Product Change Notice (PCN)

PCN Number: **PCN-0451088R-01**

Product(s) Affected: **PJ-040-SMT-TR**

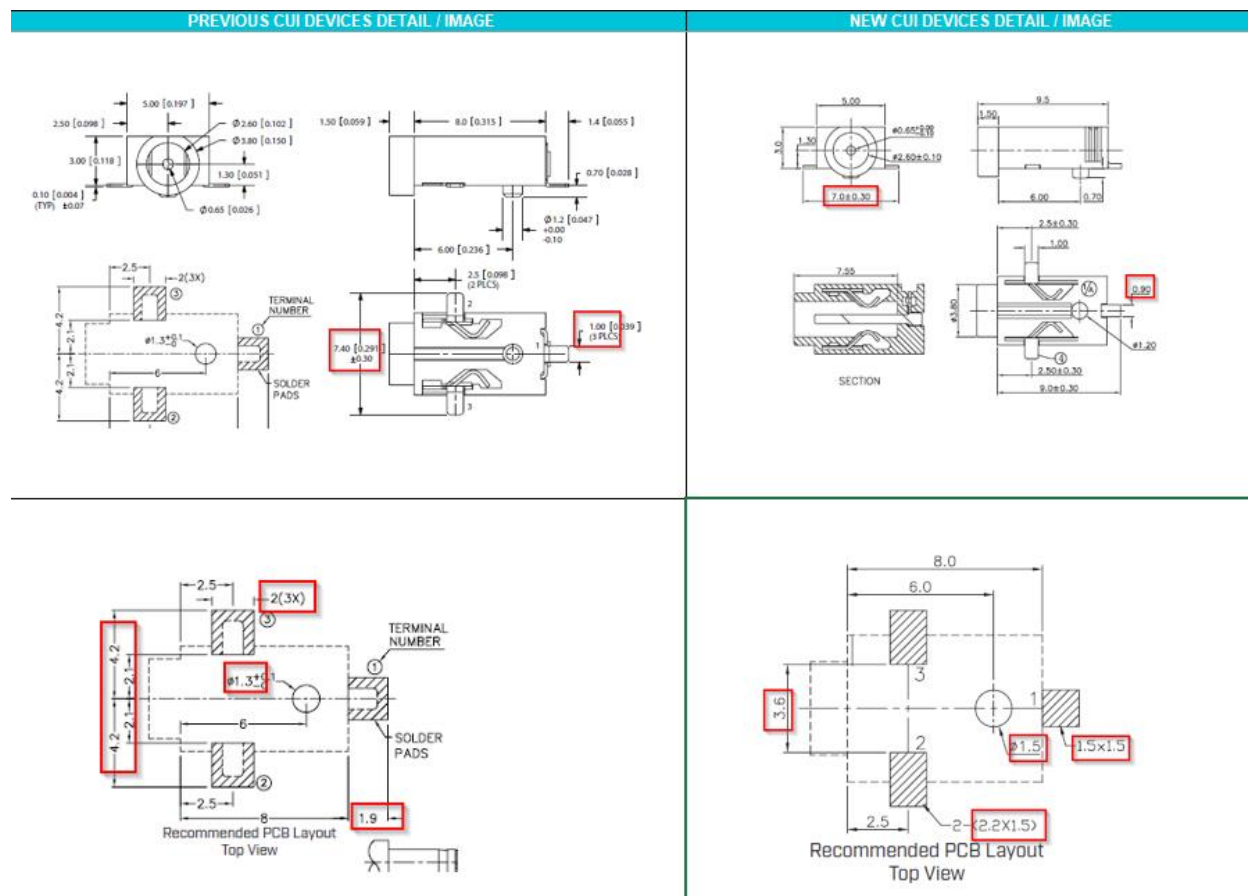
Description of Change: **Minor Housing and footprint differences. Material Change on the housing and terminals. See image Below**

PREVIOUS CUI DEVICE'S DETAIL / IMAGE

MATING PLUG
Jack Insertion Depth: 2.7mm

NEW CUI DEVICE'S DETAIL / IMAGE

MATING PLUG
Jack Insertion Depth: 2.55 mm

MATERIAL	PLATING
center pin	copper	nickel
terminal 1	brass	silver
terminal 2	copper alloy	silver
terminal 3	copper alloy	silver
plastic	PA6T or equivalent

DESCRIPTION	MATERIAL	PLATING/COLOR
center pin	bronze	silver
terminal 1	bronze	silver
terminal 2	SUS301 t=0.20 mm	gold
terminal 3	SUS301 t=0.20 mm	gold
housing	PA10T (UL94V-0)	black
